Proposed Revisions to a Standard Plans Index

Originator:	Turley, Joshua	Index Number:	455-130
Date:	8/21/2024	Sheet Number(s):	2
E-mail:	Joshua.Turley@dot.state.fl.us	Index Title:	30" SQUARE CFRP & SS PRESTRESSED CONCRETE PILE

30" SQUARE CFRP & SS PRESTRESSED
CONCRETE PILE

INDEX
455-130

STRAND PATTERN

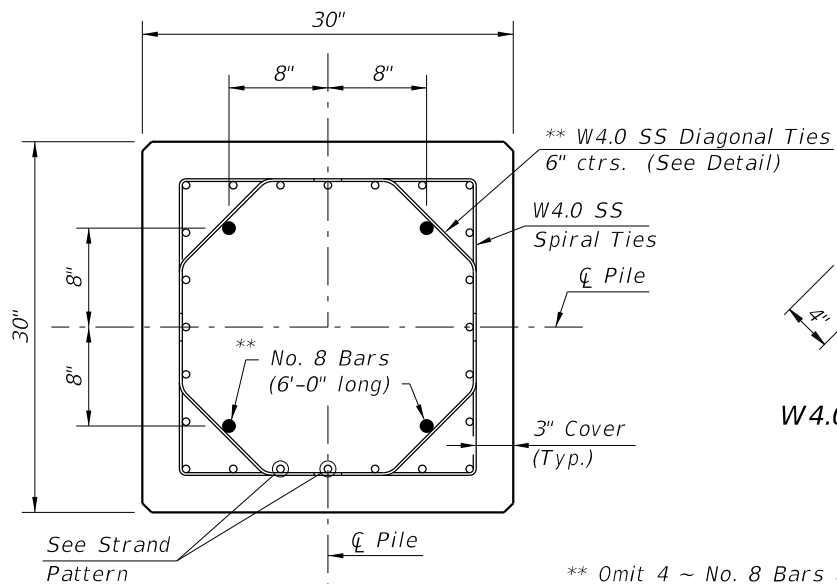
Sheet 2: Adjusted Strand Pattern diameter decimal places

32 1/2" Ø, HSSS at 26 kips
24 0.6" Ø, HSSS at 35 kips

CHANGED TO: 0.620"

This is a more accurate representation of the nominal diameter driven by the fact that the strands are fabricated in millimeters not inches.

STRAND PATTERN

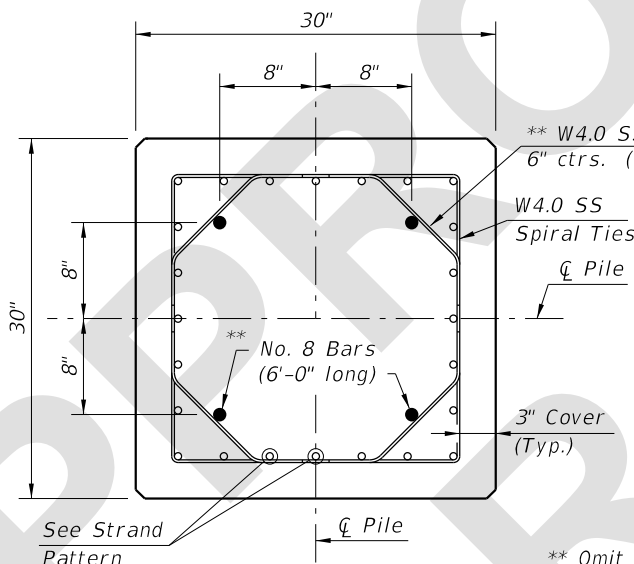
- 32 ~ 0.52" Ø, HSSS at 26 kips
- 24 ~ 0.62" Ø, HSSS at 35 kips
